Redlake Mixed Use Development at Tomago, NSW

Further to your e-mail of 21 October 2008, we have reviewed ADW Johnson's responses to queries raised by the Department of Planning about water management at the Redlake development at Tomago. Their responses indicate some improvements to the water management scheme, and they have provided information to address some of the gaps in the Environmental Assessment Report, however some concerns also remain.

Figure 3: Areal potential evapotranspiration across Australia (Bureau of Meteorology)

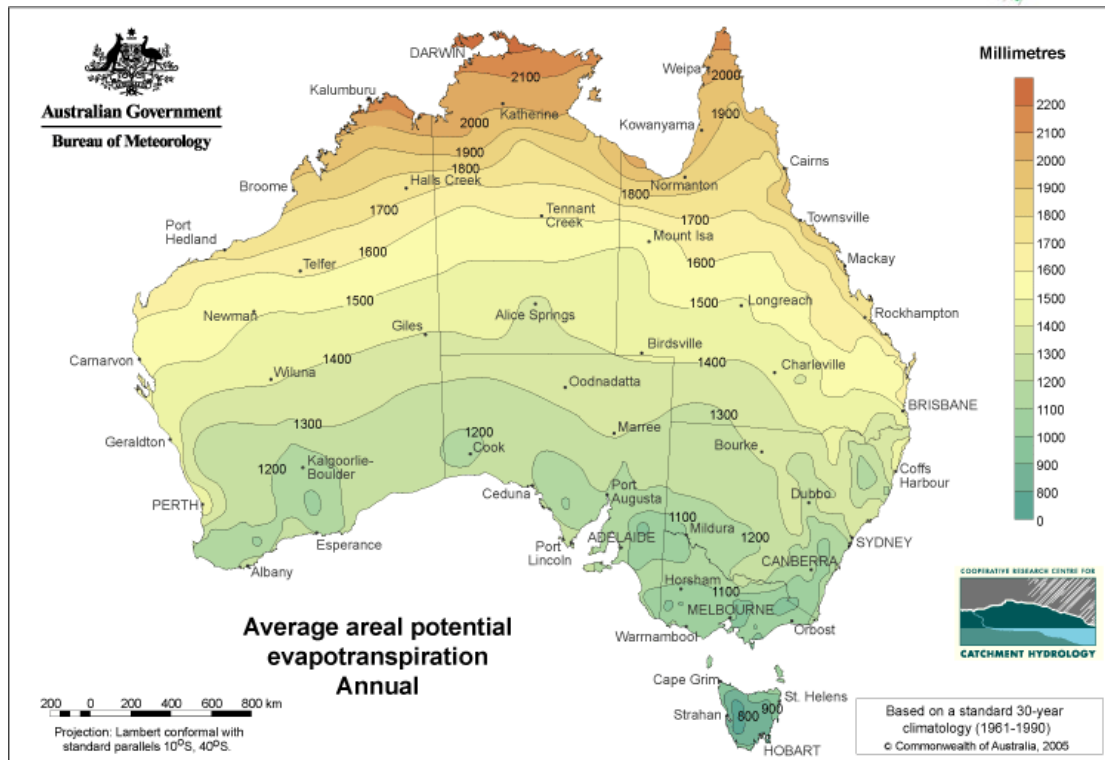
- The potential evapotranspiration (PET) rate quoted by ADW Johnson is 1,731 mm/year, which is very high for the central NSW coast. 1,731 mm/year is more typical of Rockhampton than Tomago. The Bureau of Meteorology's areal PET map for Australia is shown in Figure 3 and shows that the PET at the site is between 1,300 and 1,400 mm/year (note that the PET values in MUSIC should be areal PET rather than point PET). Evapotranspiration losses are therefore overestimated.
